ENGINEERING MEMORANDUM

SLEEVE REPAIR TO TRUSS AT 189212 ATTACHMENT.

E. M. NO.		12066		FILE CODE	111
EFFECTIVE		48 required		COPYES TO	NO
DWG. NO.	JOB NO.		CUSTOMER'S ORDER NO.	ENG.	3
CUSTOMER		RCAP		INSPEC	6
TYPE AIRCRAFT		Expeditor		PROD	9
AIRCRAFT REGISTRATION NO.		PLANNING		PLANNING	2
DATE		JUL 14/56		MAT. CONT.	2
DWG. CHANGE		YES		CONT. ADM.	1
NO		NO		R.C.A.F.	2
				FIELD	1
				DWG. CONT.	4

ISSUE	DATE	REVISION	APPROVALS
A	JUN 14 '58	ORIGINAL ISSUE, SHTS. 1 TO 3	ON SH. 1
B	NOV. 4 '59	SH. 4 ADDED	ON SH. 1

SLEEVE REPAIR TO TRUSS
AT 189212 ATTACHMENT

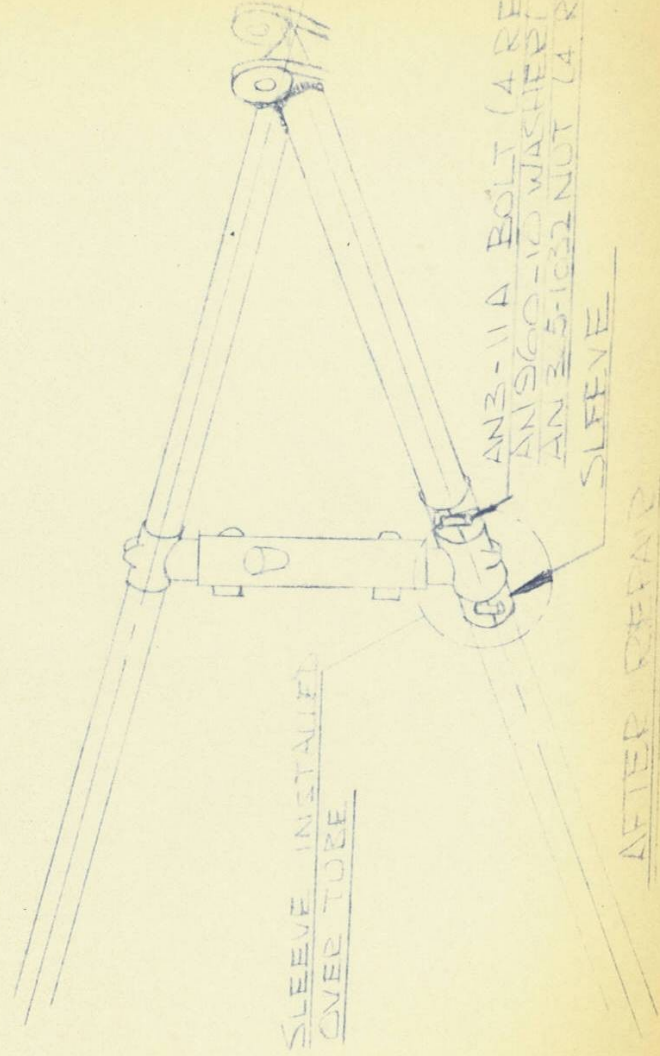
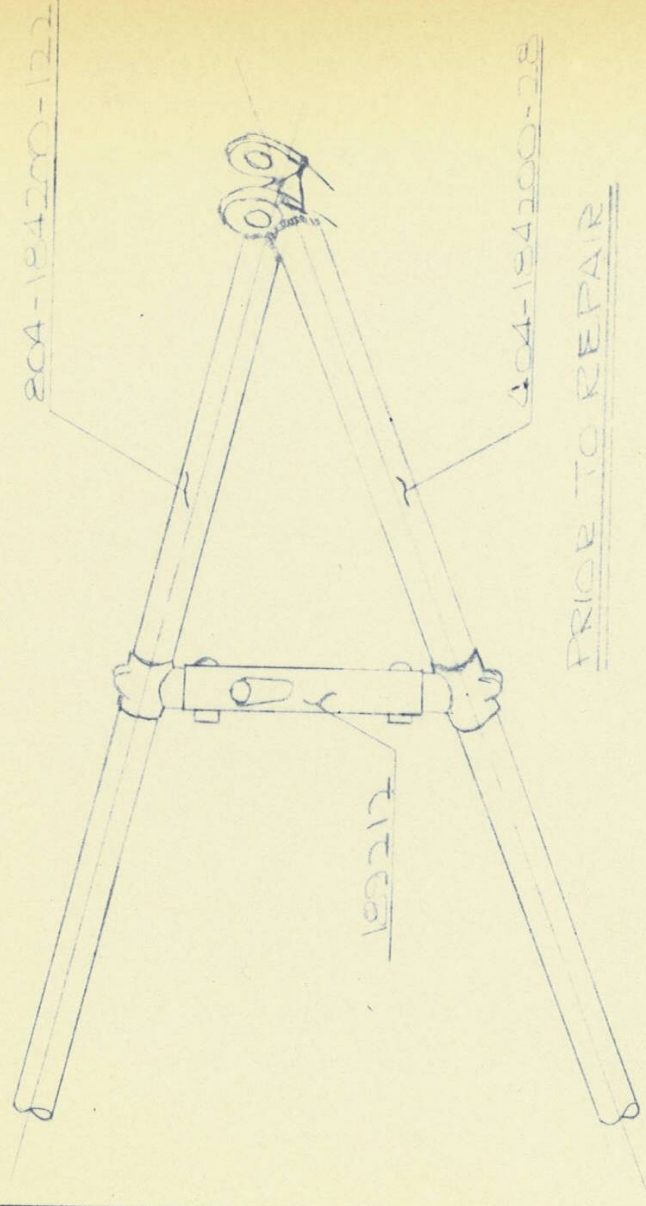
Cases of considerable wear have been encountered on the Expeditor truss at points of attachment of 189212 bracket since the bracket is frequently improperly secured. As a result, wear occurs under the action of vibration and backfiring.

In cases where truss tubes 404-184200-28 and 804-184200-122 wear at the points of attachment of 189212 Bracket the following repair scheme may be used. This repair scheme is restricted to cases of minor wear only. Where wear or corrosion greater than .008" occurs the Engineering Department must be consulted. For the repair, see the attached sketches.

1. Weld on side tubes
2. Stress relieve the welds
3. Cut along centre line shown

1. Clean the truss tube (s) being repaired and clean out corrosion by means of steel wool, in such a manner as to have no sharp change in cross section.
2. Prime with zinc chromate primer to MIL-P-6889.
3. Prime the sleeve with zinc chromate primer to MIL-P-6889.
4. Install the sleeve (s) in such a manner that the bracket can be installed in accordance with drawing 189210.
5. Paint the whole assembly with aluminum lacquer to MIL-L-7178.

UPPER CLAMP - REPLACES
CLAMP 189213

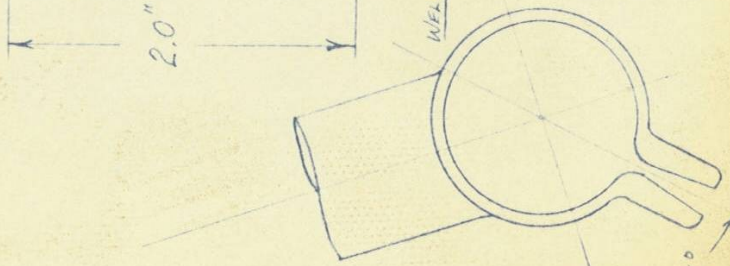
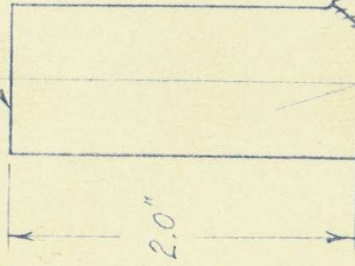
WHERE THE REPAIR SCHEME CALLED UP IN
THIS E.M. IS EMPLOYED, THE CLAMPS 189211
AND 189213 WILL HAVE TO BE REPLACED WITH
NEW CLAMPS AS SHOWN IN THE DIAGRAMS:

NOTE: 1. TUBES TO BE 4130,
MIL-T-6736A, TYPE I,
CONDITION N.

2. PARTS TO BE
CADIUM PLATED AFTER
WELDING.

3. PARTS TO BE
STRESS RELIEVED AFTER WELD
